210140-A-UPL2-117

WUSM RESEARCH BUILDING

NRB CUP

HRC VENT

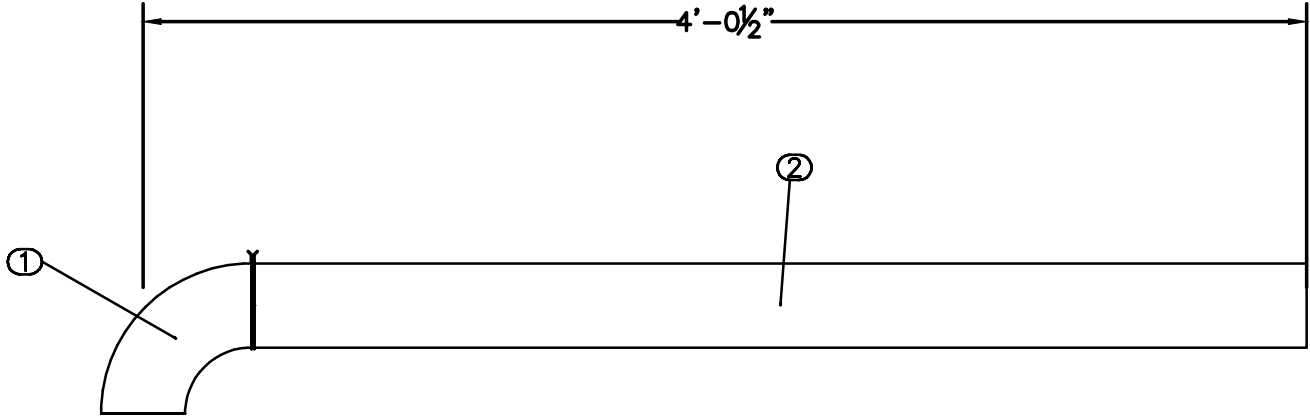
ADD BIRD SCREEN TO OPEN END 90.
